REACTIVITY CONTROL SYSTEMS

SHUTDOWN MARGIN - MODES 3, 4 AND 5

8503110443 850306
PDR ADOCK 05000395
P PDR

FIGURE 3.1-3

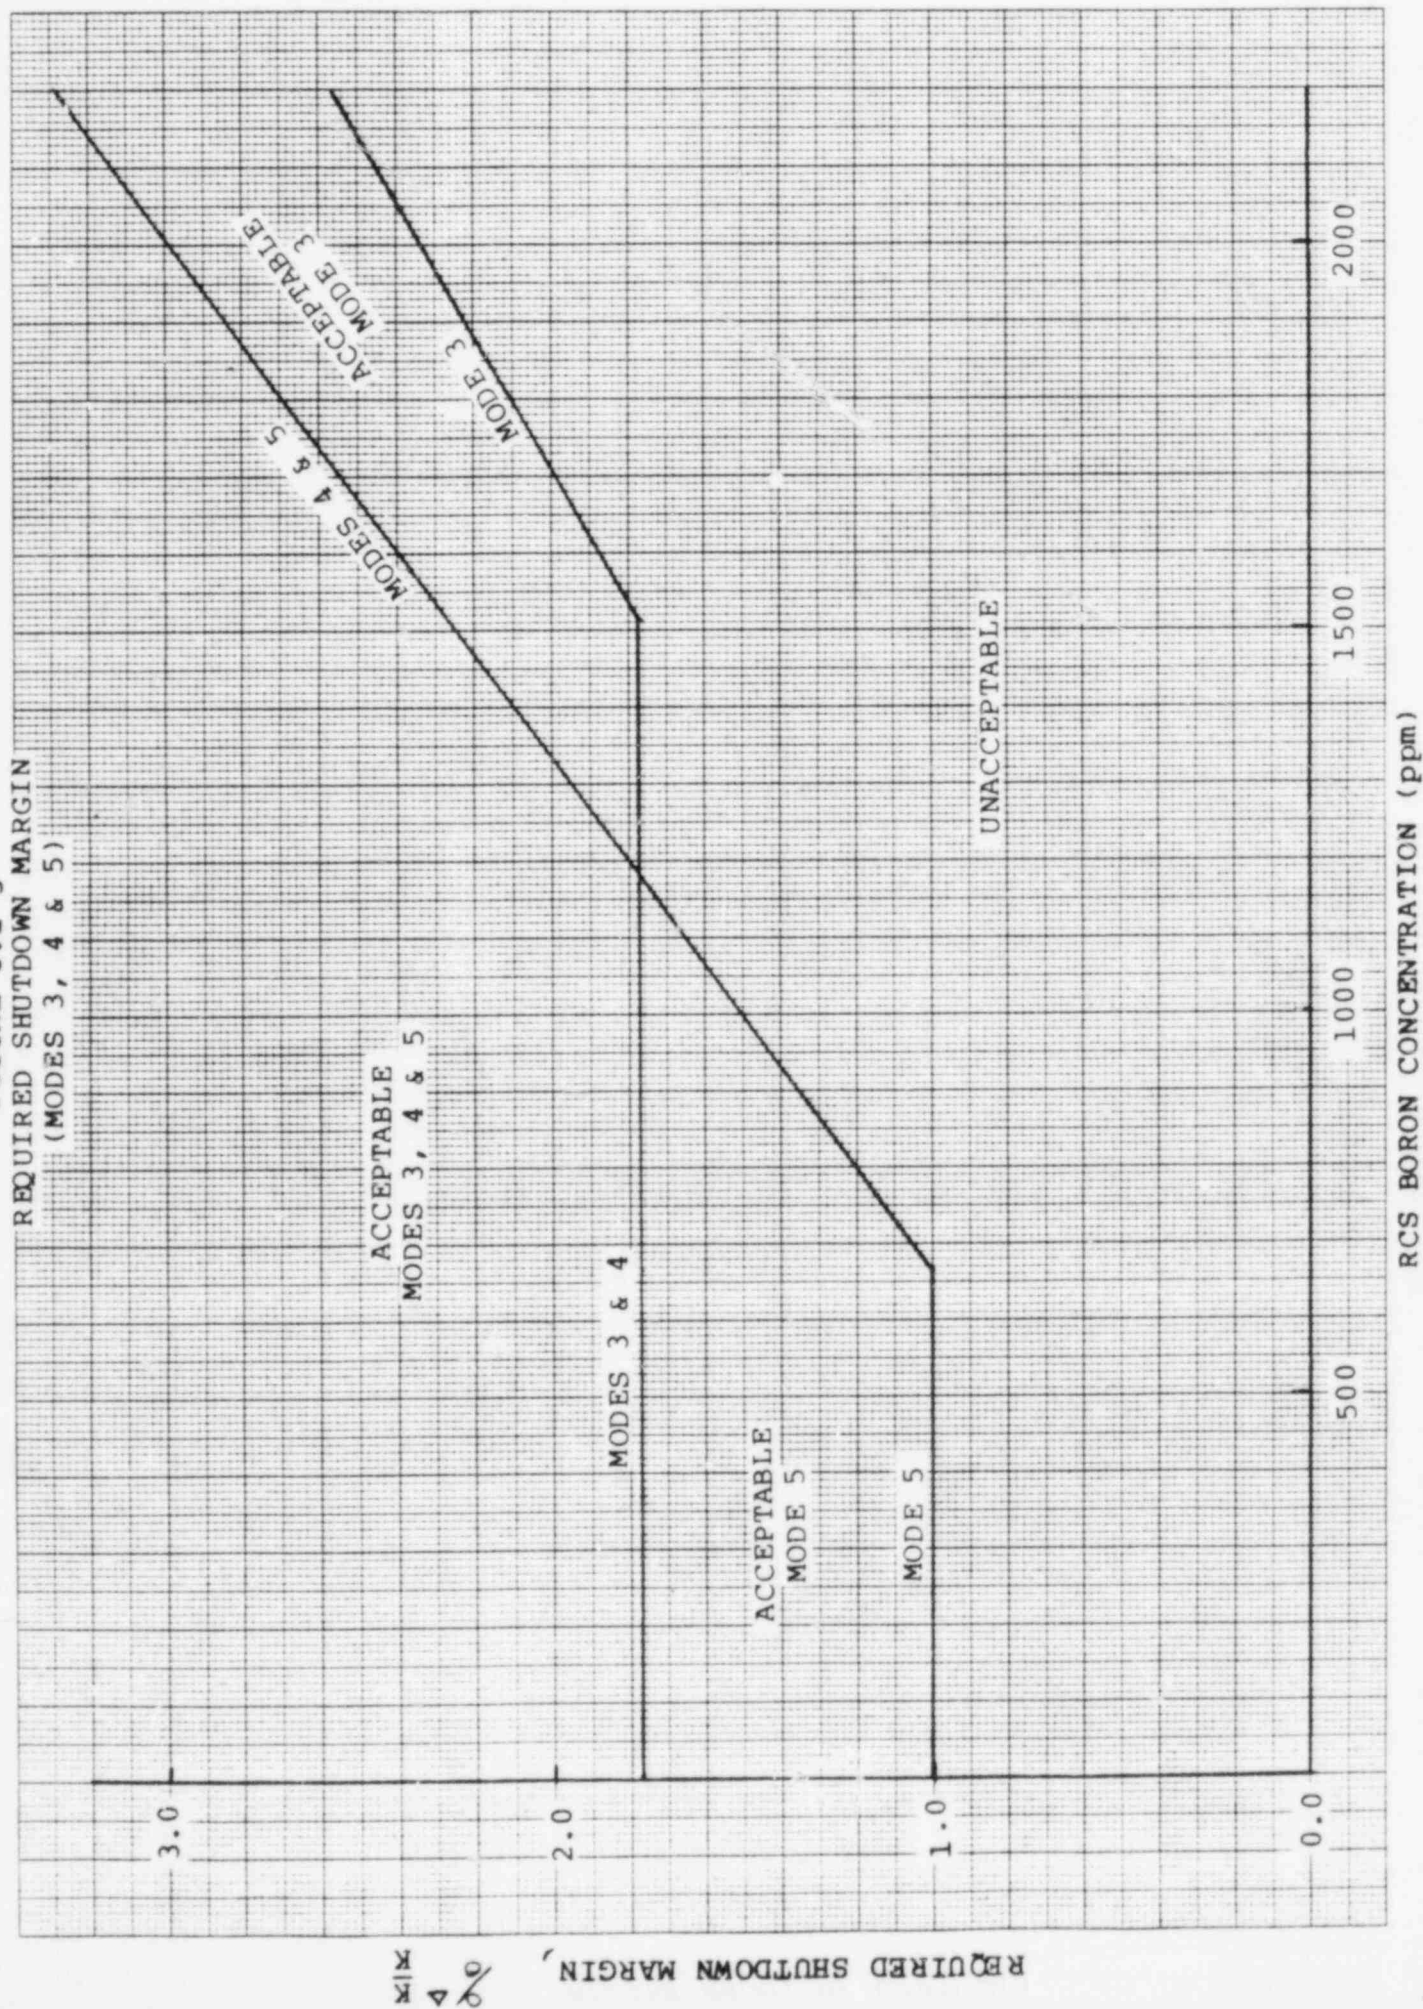
3.1.1.2 The SHUTDOWN MARGIN shall be greater than or equal to ~~2.0% delta k/k~~.

↑ THE LIMITS SHOWN IN
FIGURE 3.1-3.

With the SHUTDOWN MARGIN less than ~~2.0% delta k/k~~,^{THE REQUIRED VALUE} immediately initiate and continue boration at greater than or equal to 30 gpm of a solution containing greater than or equal to 7000 ppm boron or equivalent until the required SHUTDOWN MARGIN is restored.

4.1.1.2 The SHUTDOWN MARGIN shall be determined to be greater than or equal to ~~2.0% delta k/k~~:^{THE REQUIRED VALUE:}

SHUTDOWN MARGIN requirements vary throughout core life as a function of fuel depletion, RCS boron concentration, and RCS T_{avg} . In MODES 1 and 2 the most restrictive condition occurs at EOL, with T_{avg} at no load operating temperature, and is associated with a postulated steam line break accident and resulting uncontrolled RCS cooldown. In the analysis of this accident, a minimum SHUTDOWN MARGIN of 1.77 percent delta k/k is required to control the reactivity transient. Accordingly, the SHUTDOWN MARGIN requirement is based upon this limiting condition and is consistent with FSAR safety analysis assumptions. In MODES 3, 4 and 5 the most limiting accident is a boron dilution accident. ~~A 2 percent delta k/k~~ ^{THE} SHUTDOWN MARGIN provides adequate protection in these MODES.

↑
IS VARIED AS A FUNCTION OF AVERAGE
RCS BORON CONCENTRATION IN ORDER TO
